Control Room Design Review

Executive Summary

The South Texas Project

HOUSTON LIGHTING & POWER COMPANY

DEMARCATIION
STUDY PANELS
Figure 2-4

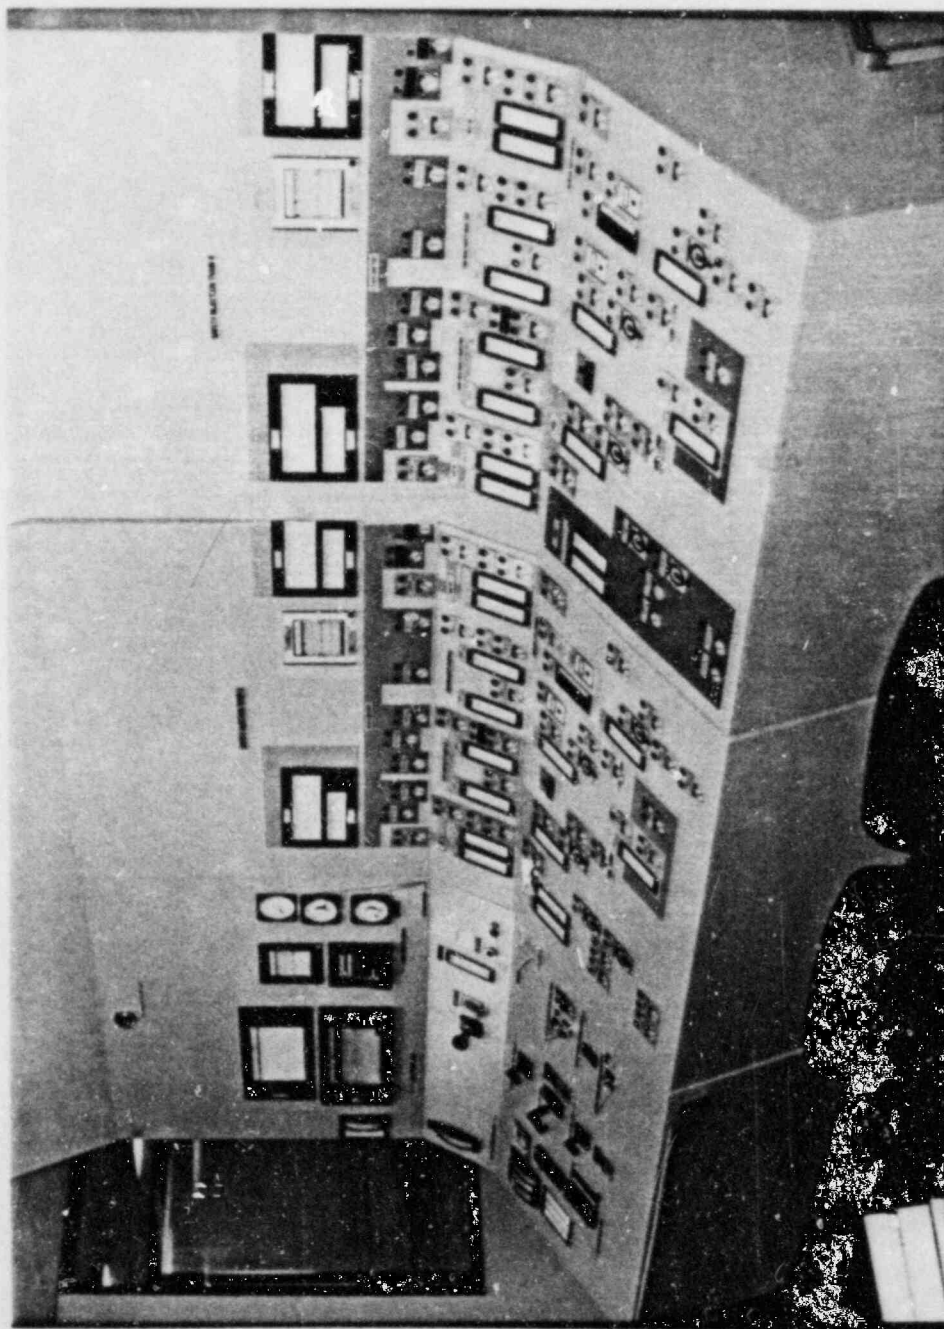
The team prepared a set of criteria for demarcing the control boards. After studying various methods, a recommendation was made to use beige for a basic panel color, with a color pad technique used for highlighting and grouping controls (see figure 2-4).

ZONE MARKING EXAMPLE
Figure 3-6

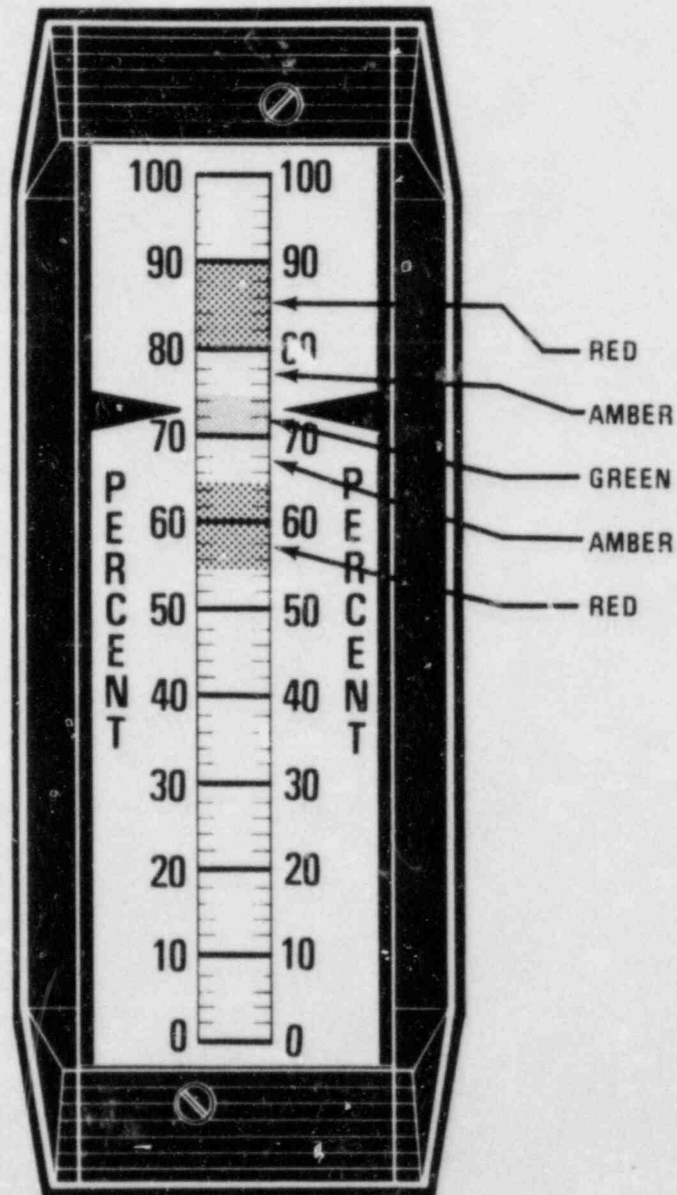
3. The methodology for zone coding meters is completed, see figure 3-6. Temporary zone coding of meters will be performed by operating personnel during startup testing. The permanent zone coding will be completed after startup verification.

FUNCTIONAL ALLOCATION FOR
PANELS CP 001, 002, AND 003

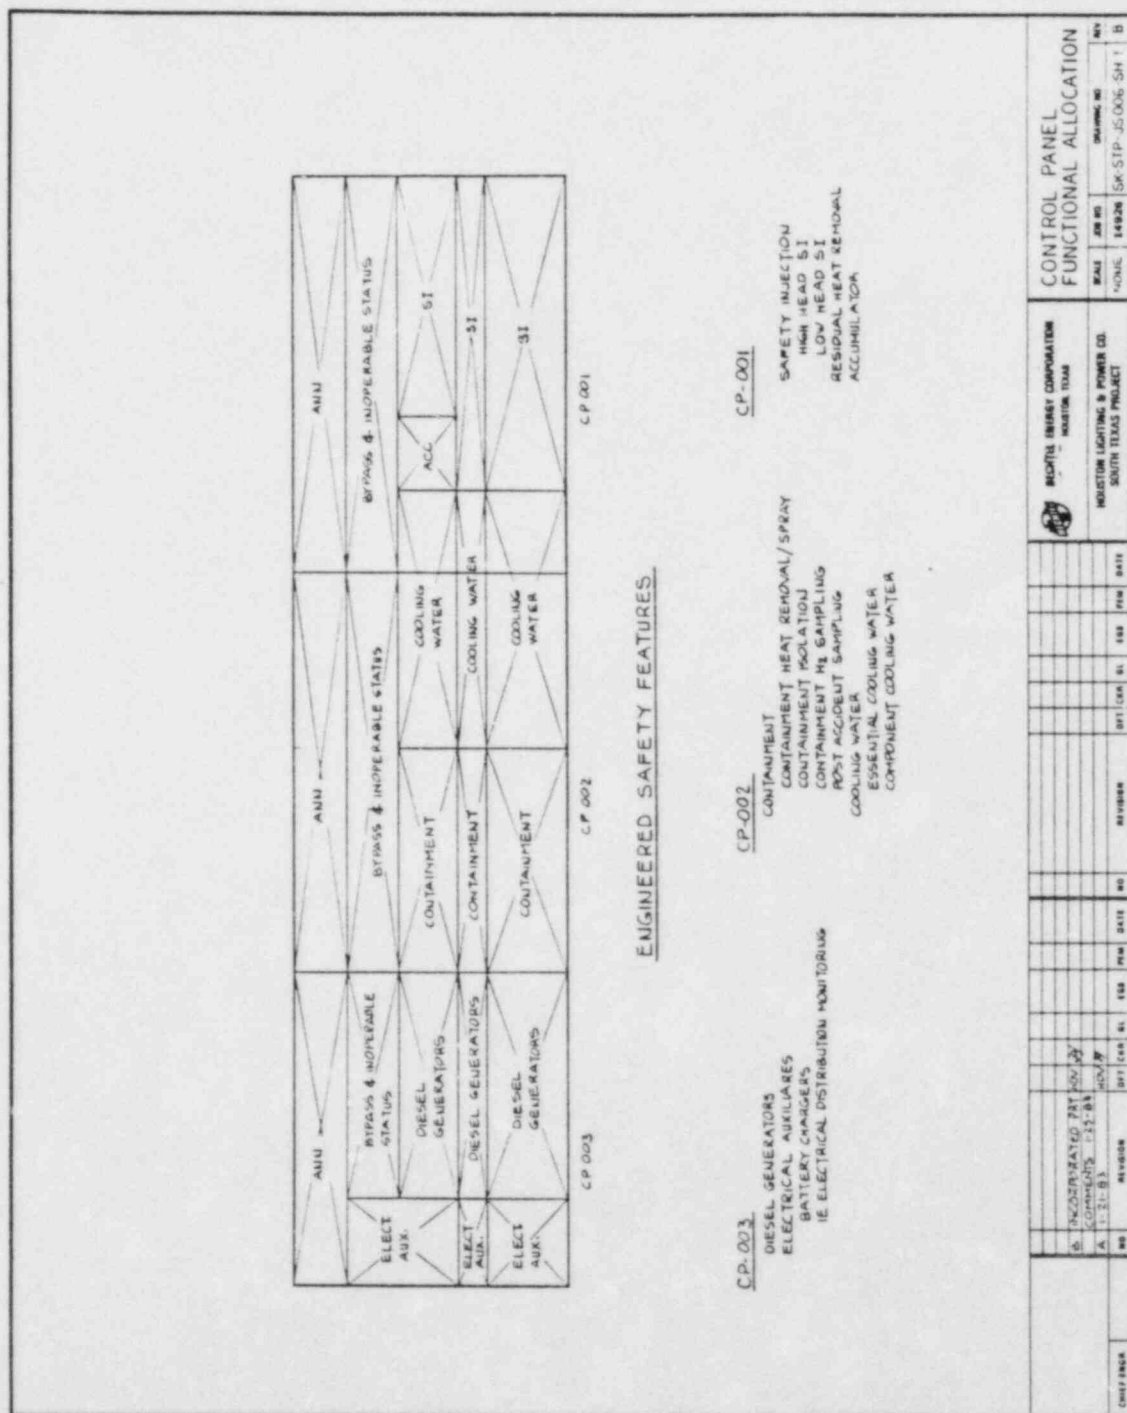
- o The original train-oriented layout of the Engineered Safety Features (ESF) panels (CP-001, 002, and 003) was totally revised to a system-oriented layout. In this redesign effort auxiliary feedwater controls were moved to CP-006 as recommended by the Operating Experience Review and SFTA. This effort permitted the correction of indicators on CP-002 that were located too high for accurate viewing. The auxiliary feedwater controls were moved from CP-001, 002 and 003 to 006. Figure 4-2 shows the functional allocation of systems for the ESF panels.

FUNCTIONAL ALLOCATION FOR
PANELS CP004, 005 AND 006

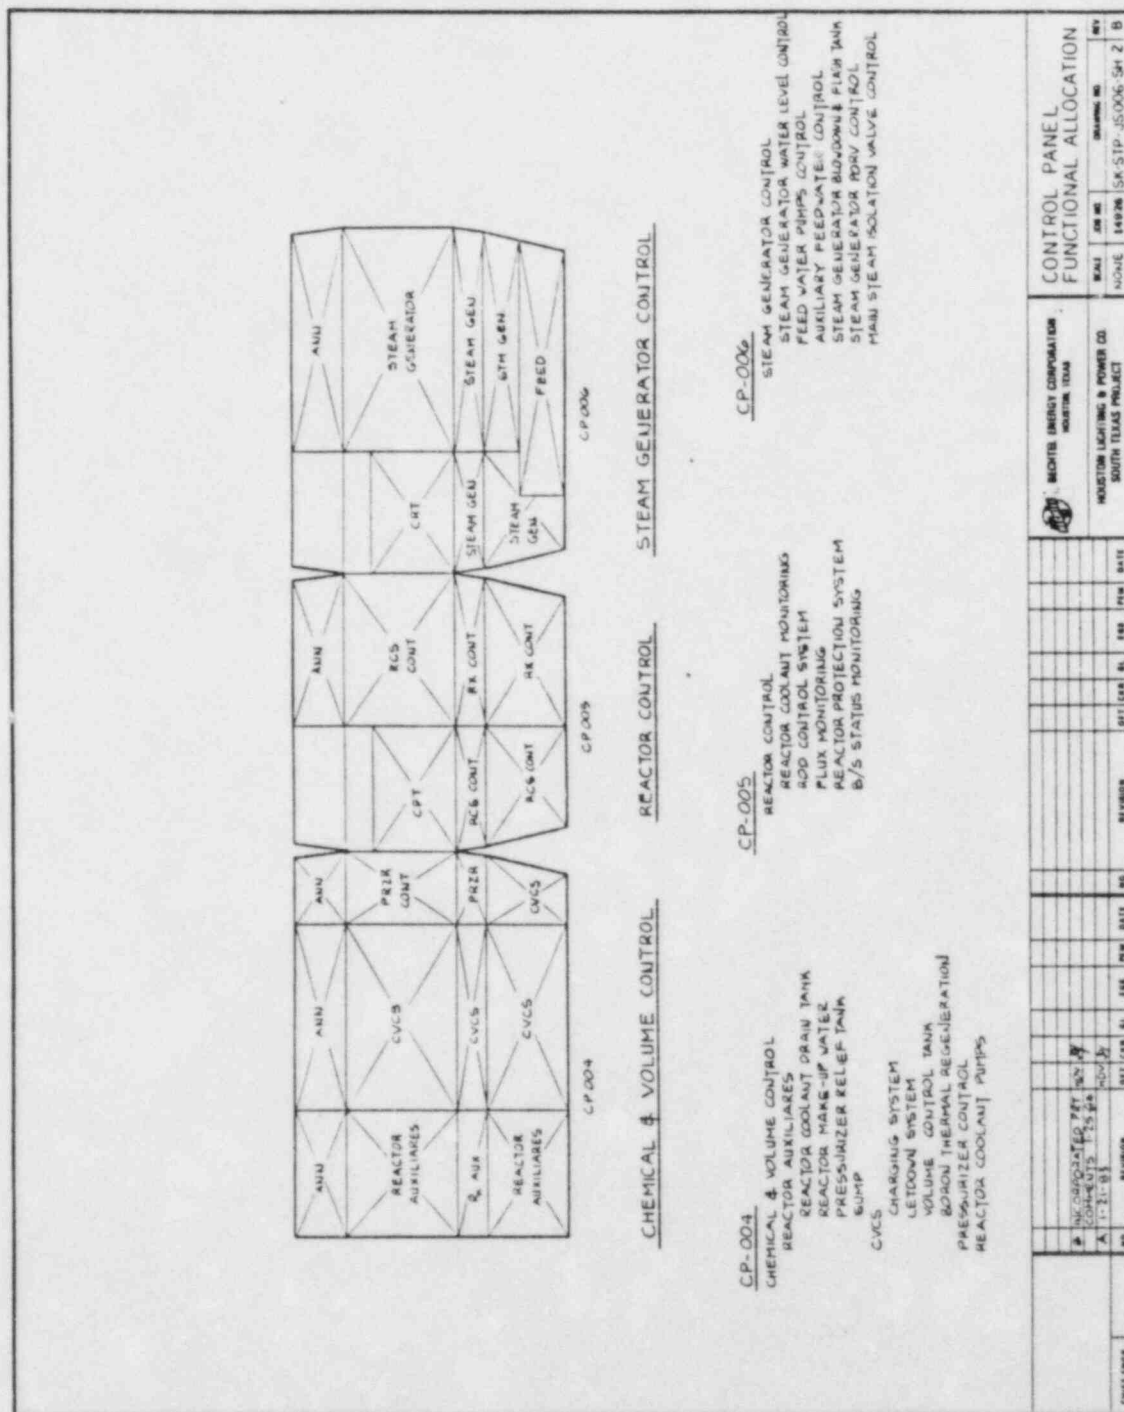
- o The controls, CRT and associated keyboard for radiation monitoring have been relocated on the operators console and recorder panel. Figure 4-3 shows the revised functional allocation for CP-004, CP-005 and CP-006. Major layout changes were made to satisfy the apparent discrepancies noted by the OER, CRS and SFTA.

HVAC PANEL MOCK-UP

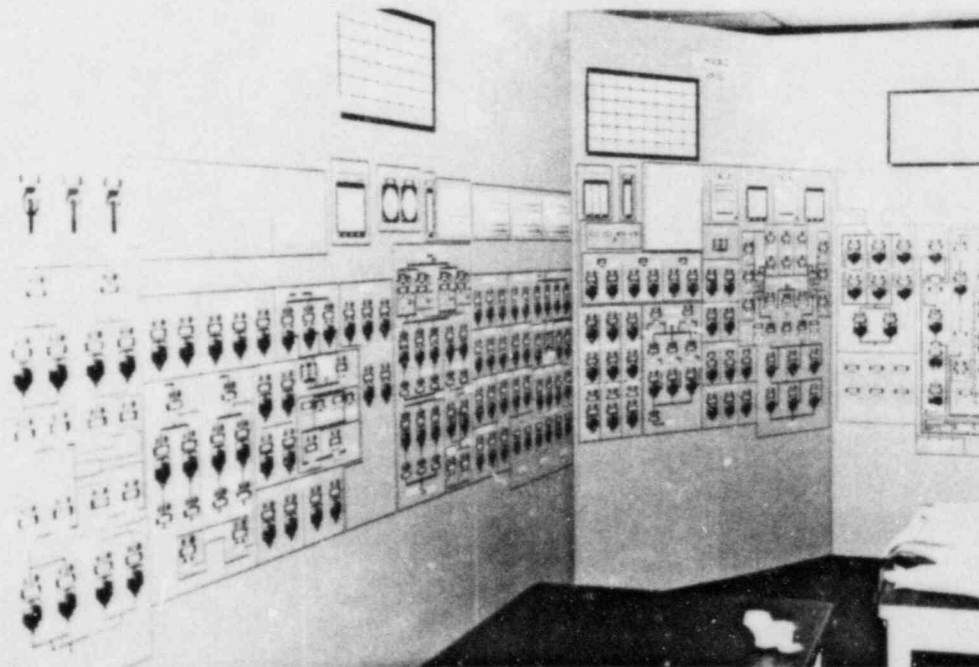
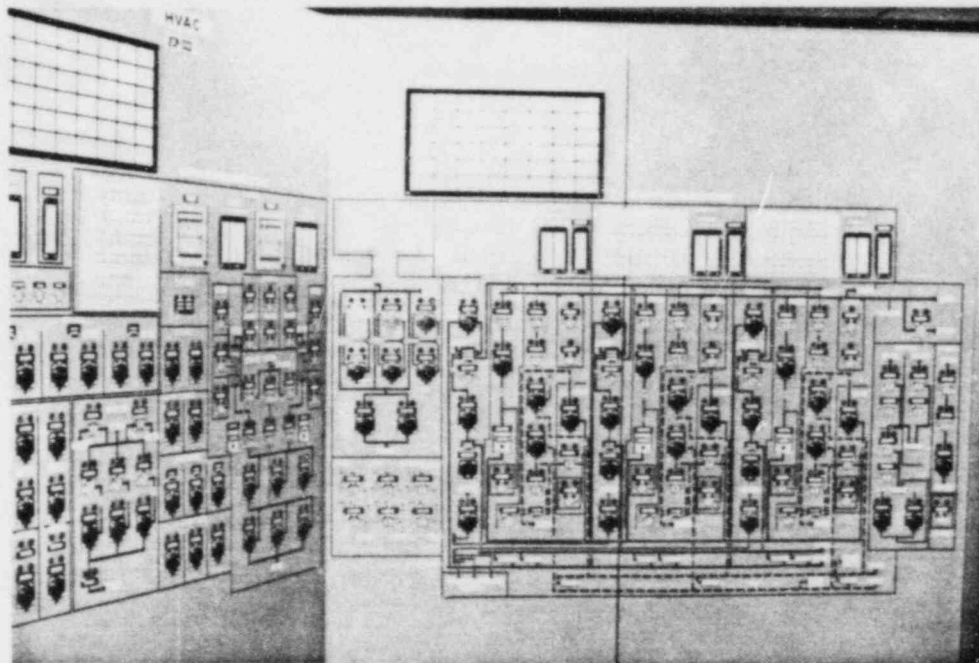
This panel has been mocked-up (See Figure 4-7) and the review results integrated in this report and pertinent support reports referenced herein.

RECORDER PANEL MOCK-UP

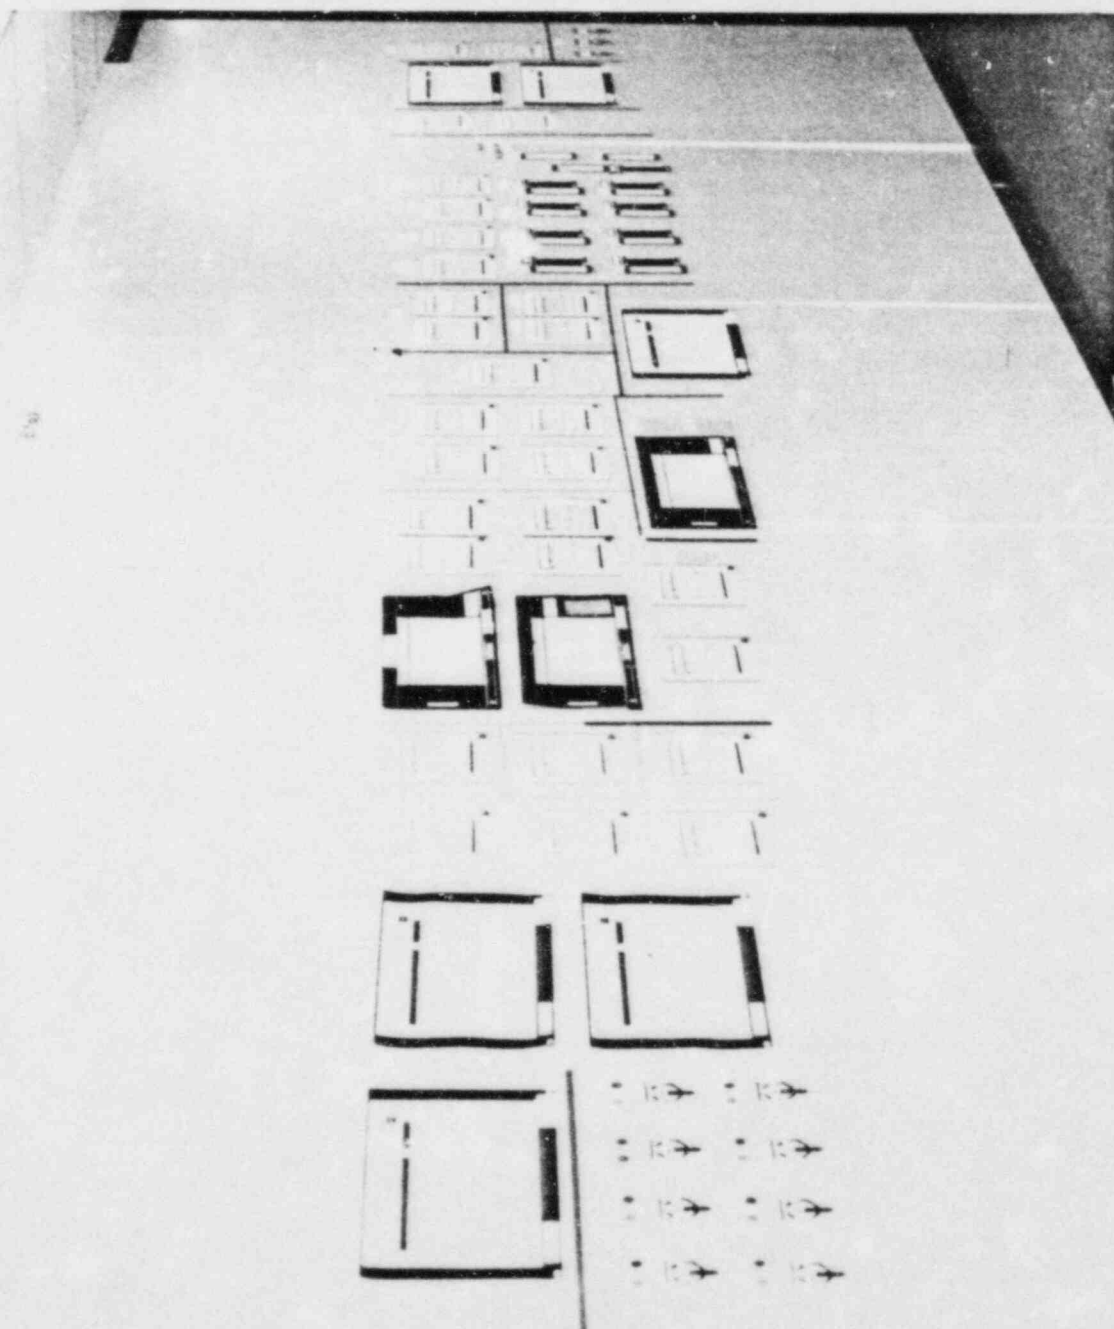
This panel has been mocked-up (See Figure 4-8) and the review results integrated in this report and pertinent support reports referenced herein.

AUXILIARY SHUTDOWN PANEL MOCK-UP

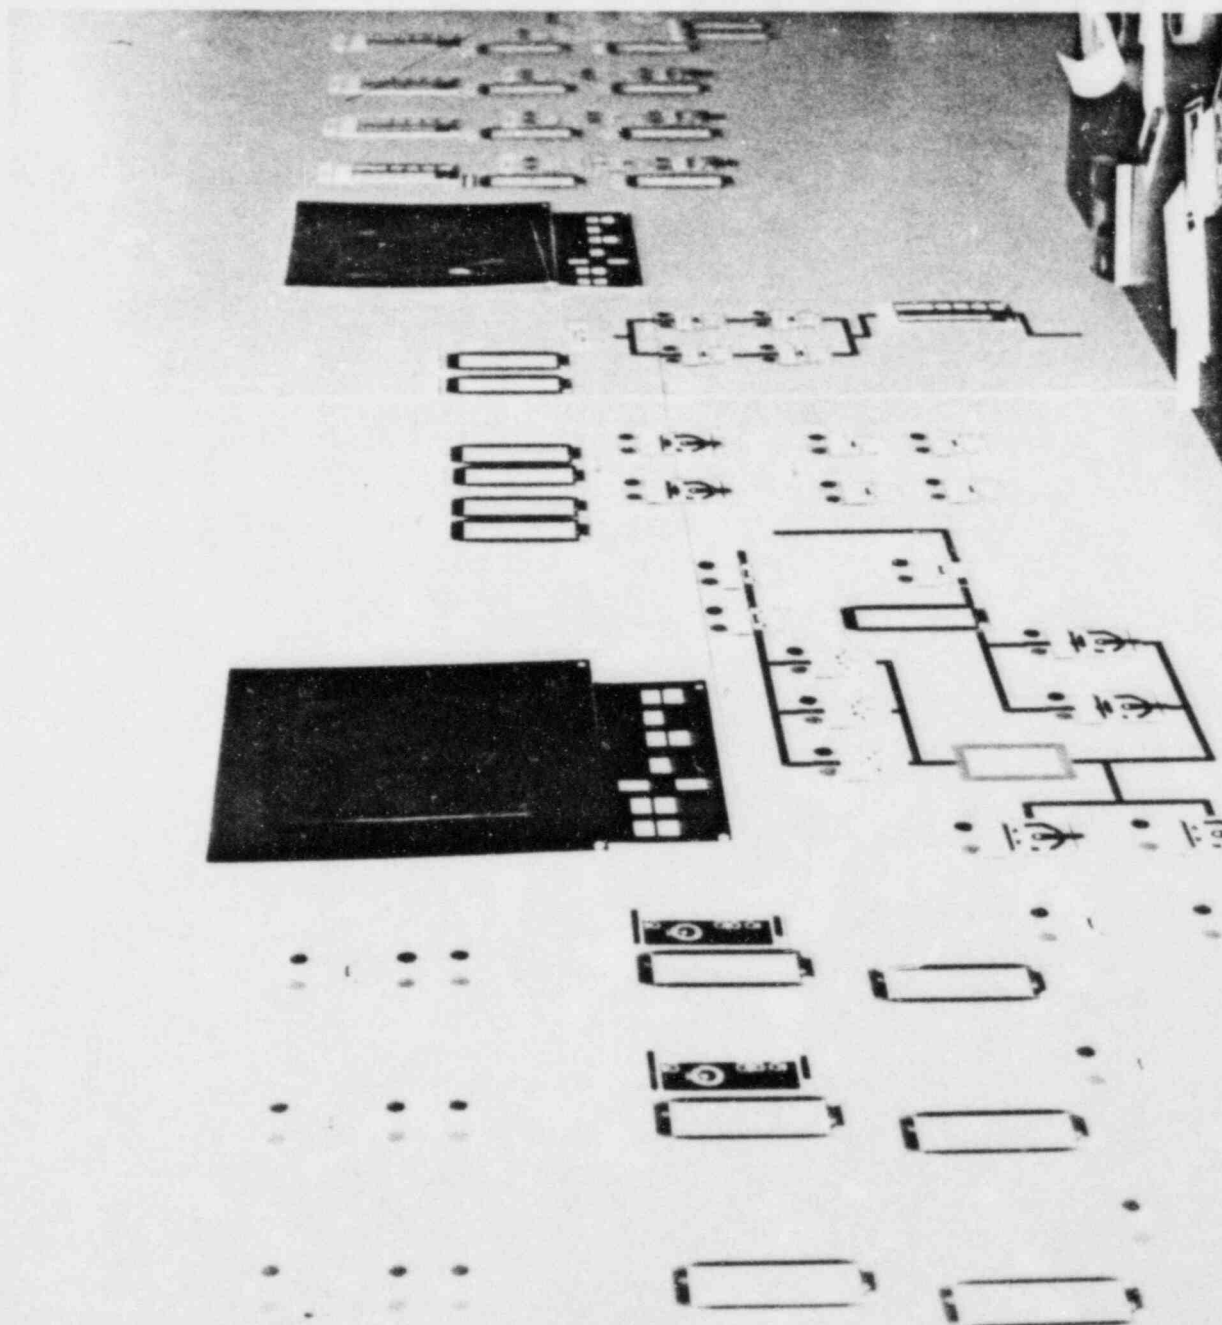
This panel has been mocked-up (See Figure 4-9) and the review results integrated in this report and pertinent support reports referenced herein.
